FED. RD. REG. NO.	STATE	PROJECT NO.	COUNTY
9	NEV.	SPS-095-2(4)	CLARK

DESCRIPTION: BRIDGE FOR GMP
DATE: 1/2/17
REVISION: 1/2/17
G.C. WALLACE, INC.
Engineering/Architecture
155 SOUTH RAINBOW BLVD. LAS VEGAS, NEVADA 89102

SHEET 95
B23
OF 135 SHEETS
1-1845W
26-3-147 107-V1882

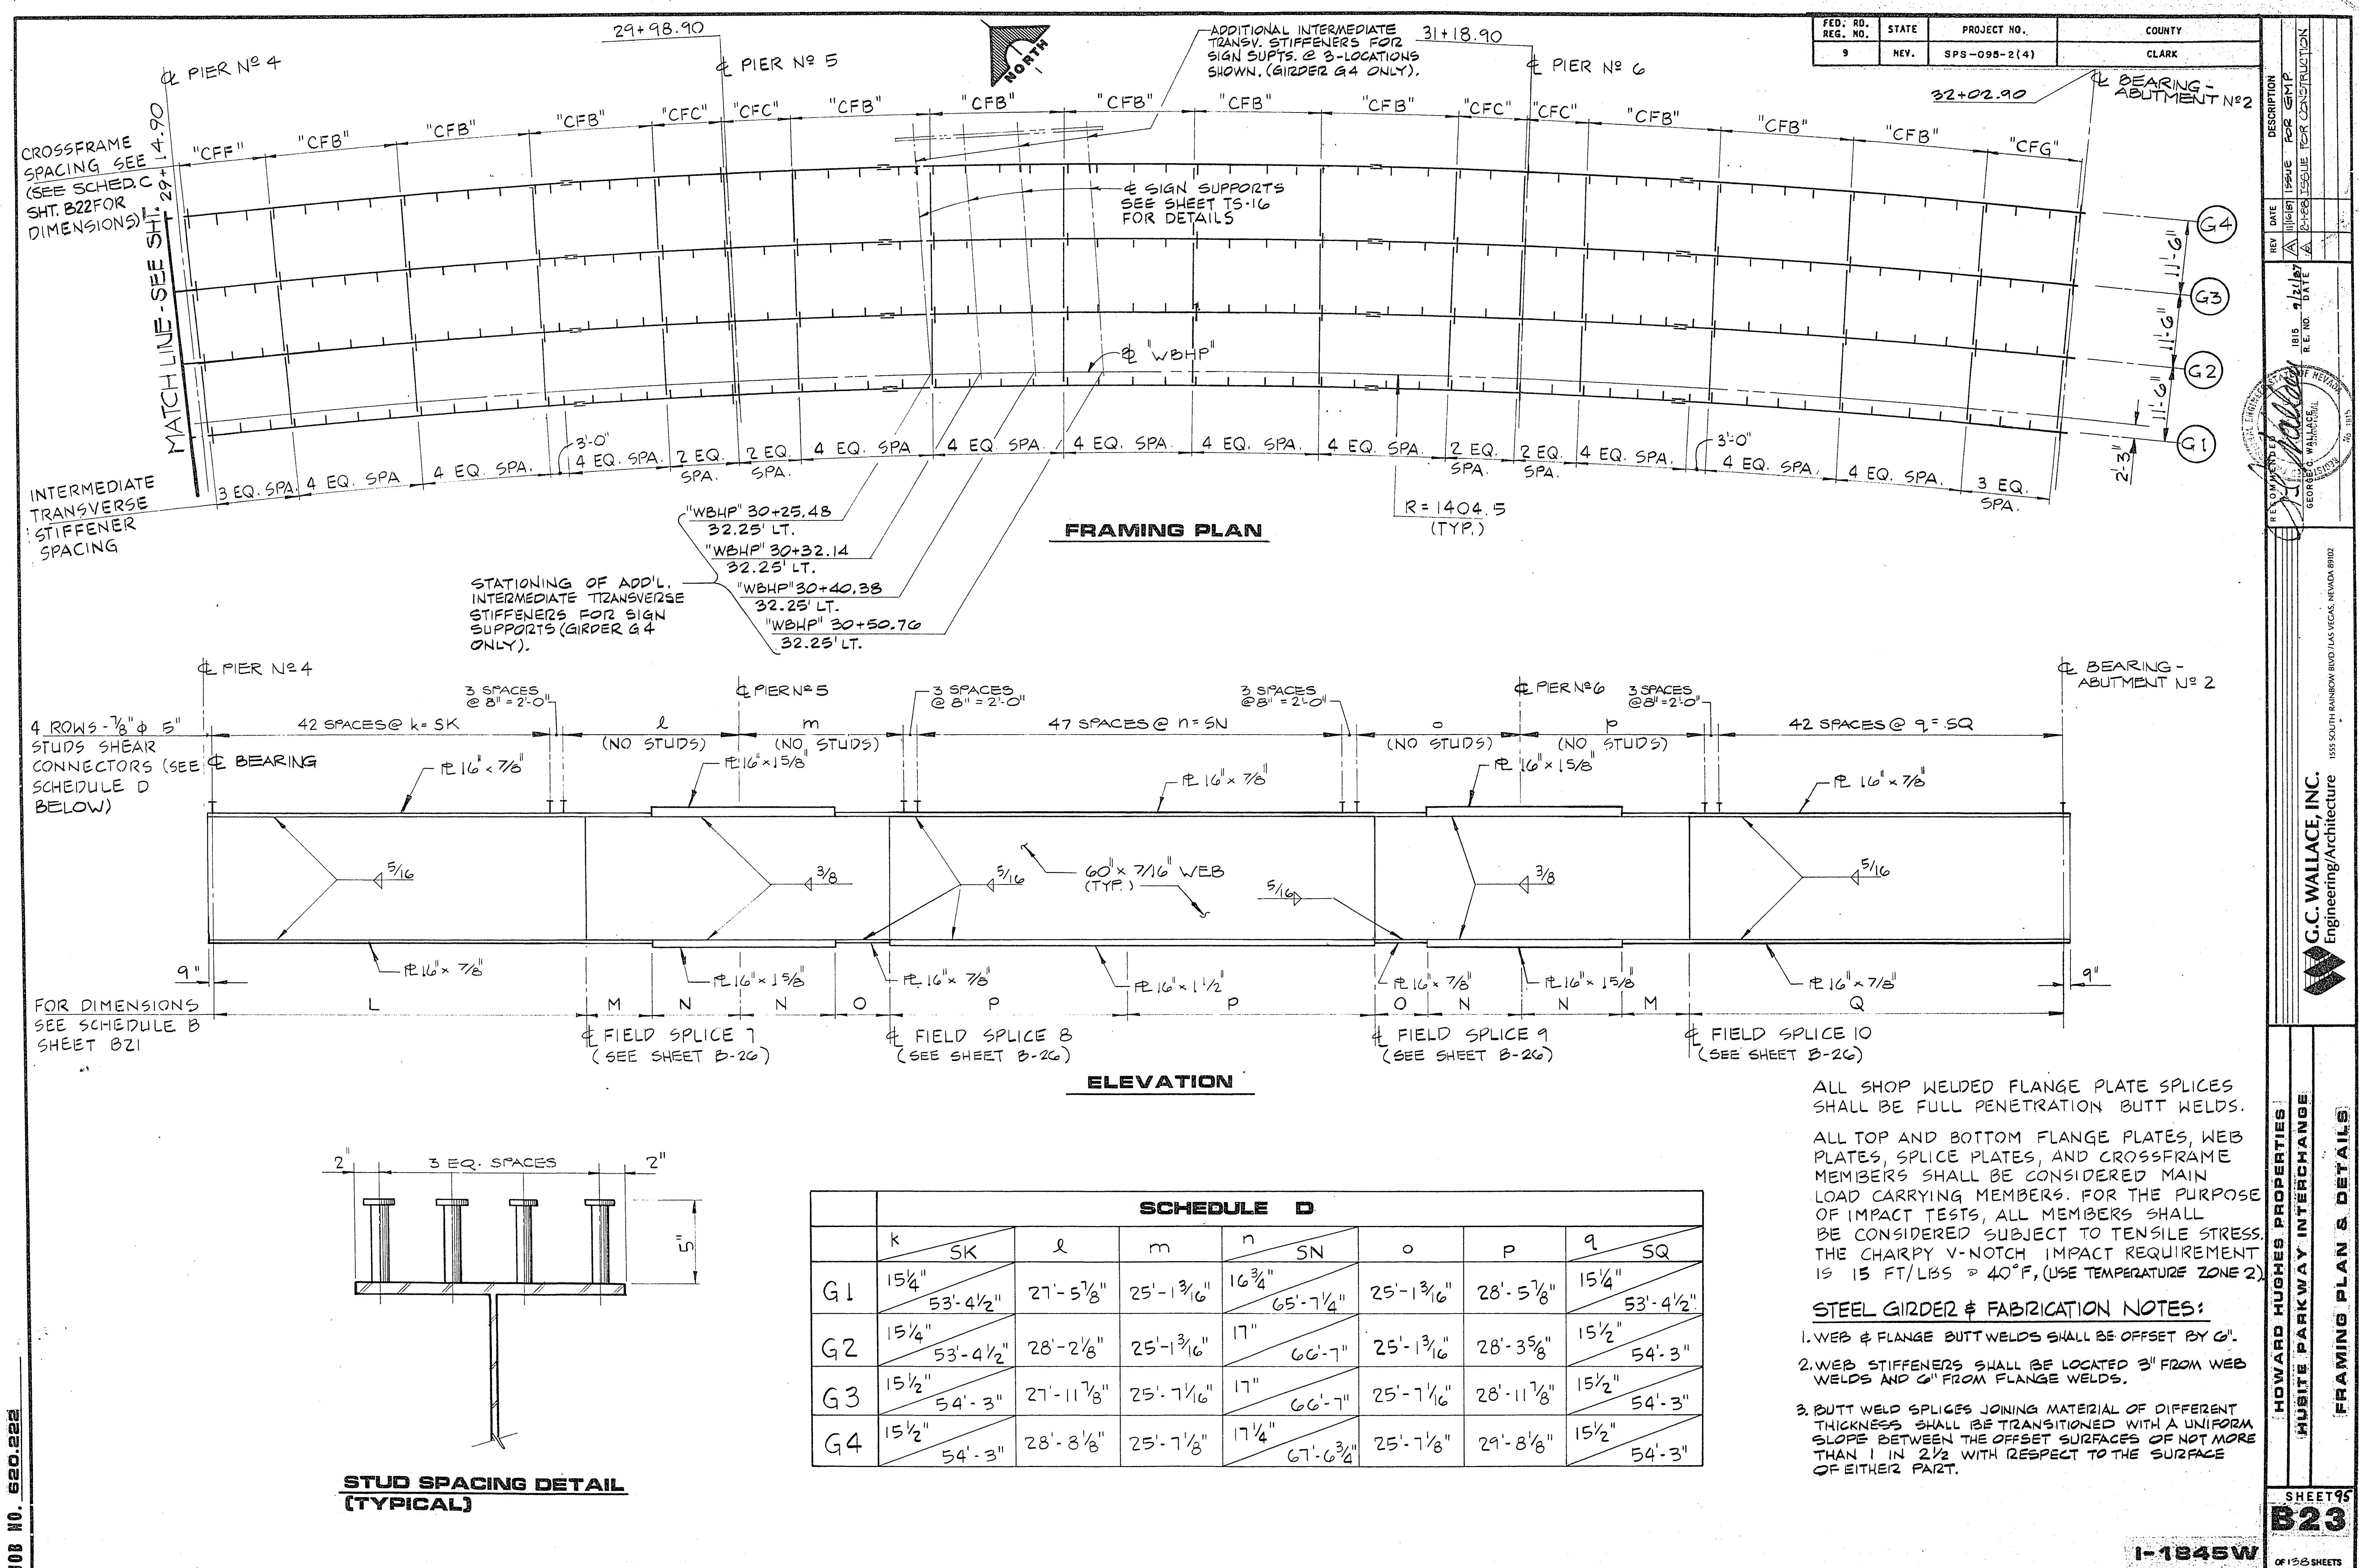
REVISIONS:
1. WEB & FLANGE BUTT WELDS SHALL BE OFFSET BY 6".
2. WEB STIFFENERS SHALL BE LOCATED 3" FROM WEB WELDS AND 6" FROM FLANGE WELDS.
3. BUTT WELD SPLICES JOINING MATERIAL OF DIFFERENT THICKNESS SHALL BE TRANSITIONED WITH A UNIFORM SLOPE BETWEEN THE OFFSET SURFACES OF NOT MORE THAN 1 IN 2 1/2 WITH RESPECT TO THE SURFACE OF EITHER PART.
